SIGNS AND MARKINGS

PALI HIGHWAY
INTERSECTION IMPROVEMENTS AT
KAMEHAMEHA HIGHWAY

F.A. PROJECT NO. STP-061-1(27)

Sheet 12, "TRAFFIC SIGNAL PLAN" Per Addendum No. 1, add Note #5.

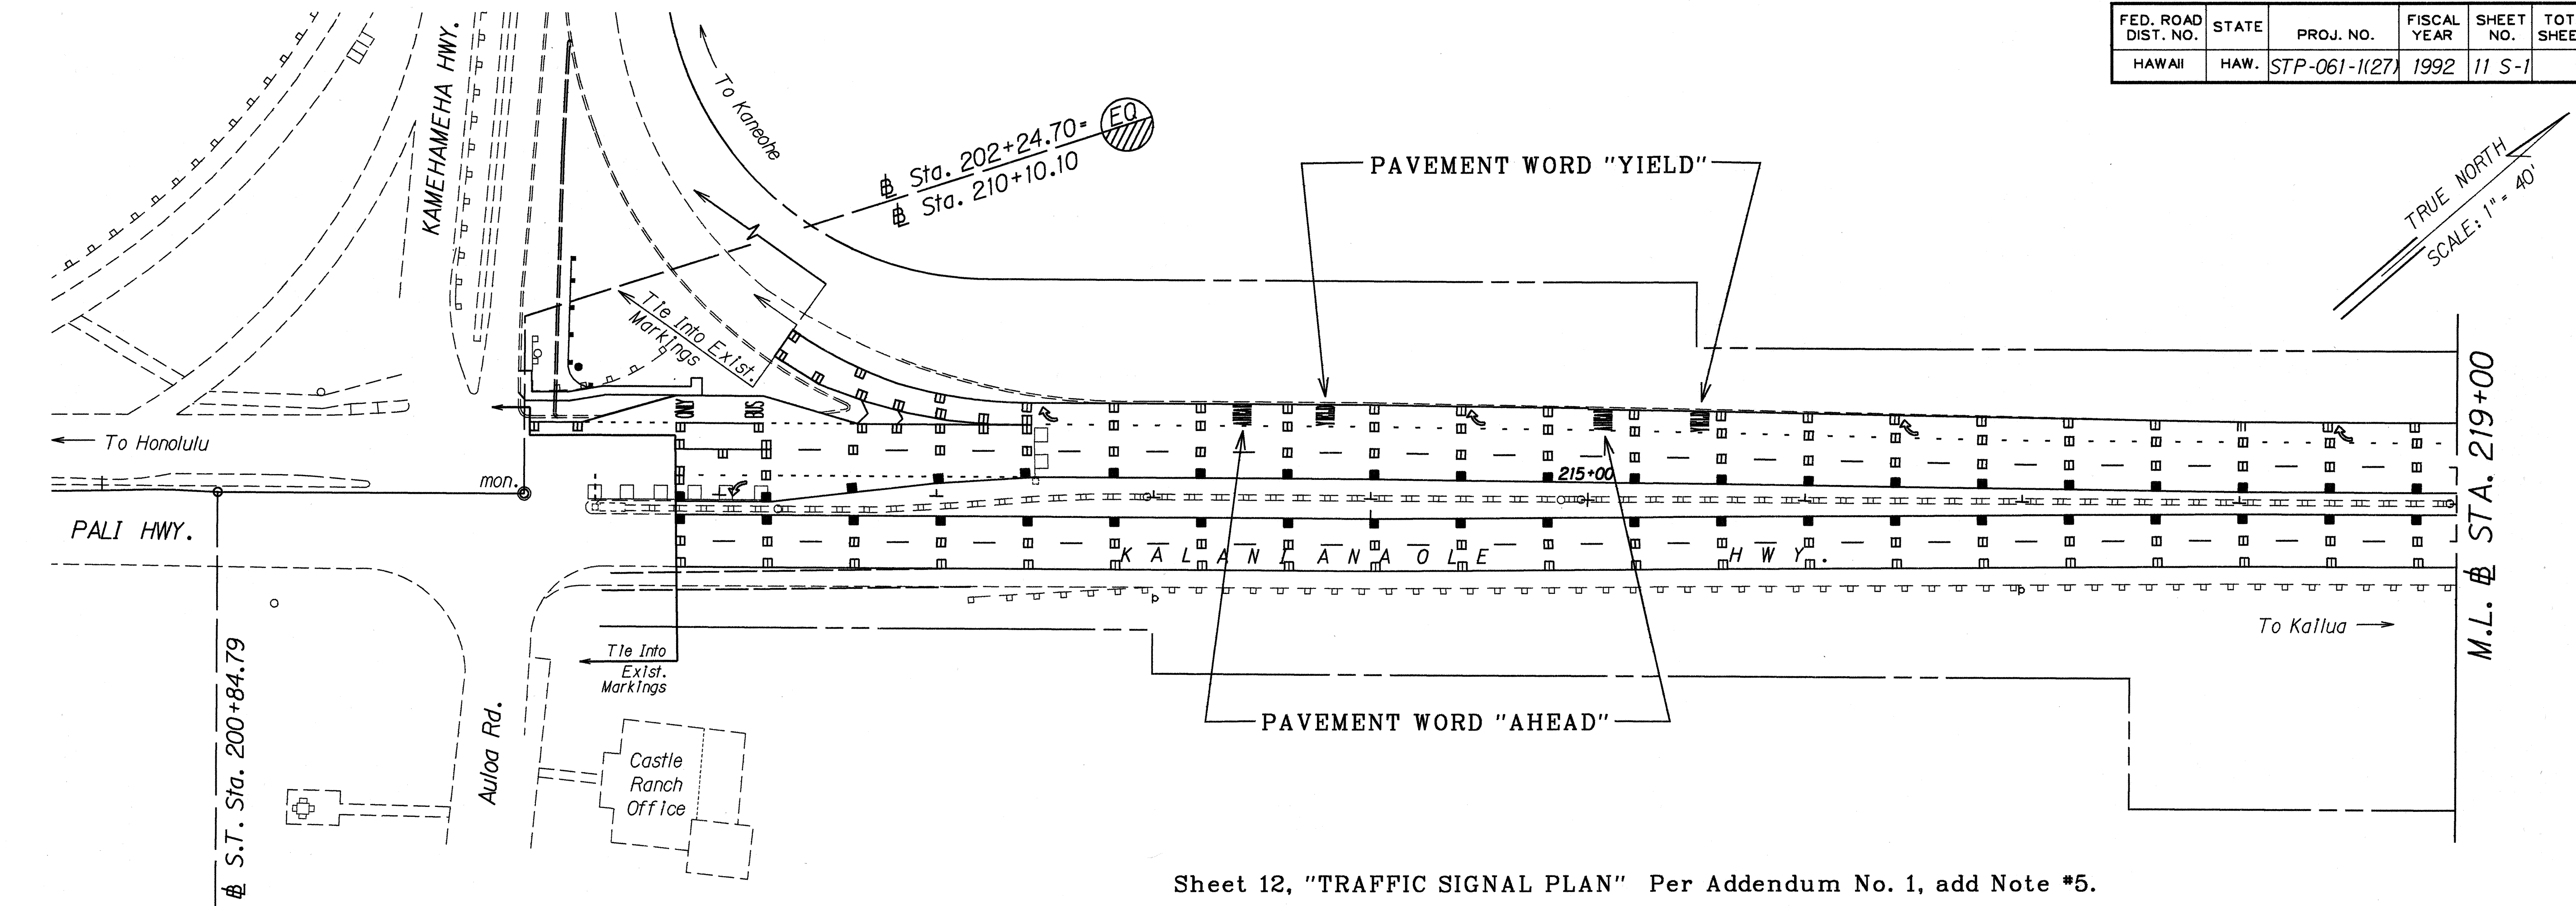
5. Furnish and install one (1) additional 2" conduit along conduit runs shown on the plan between the controller (OB Sta. 202+50, 67' LT) and the power source pole (OB Sta. 200+87, 60' RT). Also furnish and install one (1) TYPE B pullbox at the power source end of the conduit. The conduit and pullbox will be paid for at the lump sum price under Item 623.5038 of the proposal.
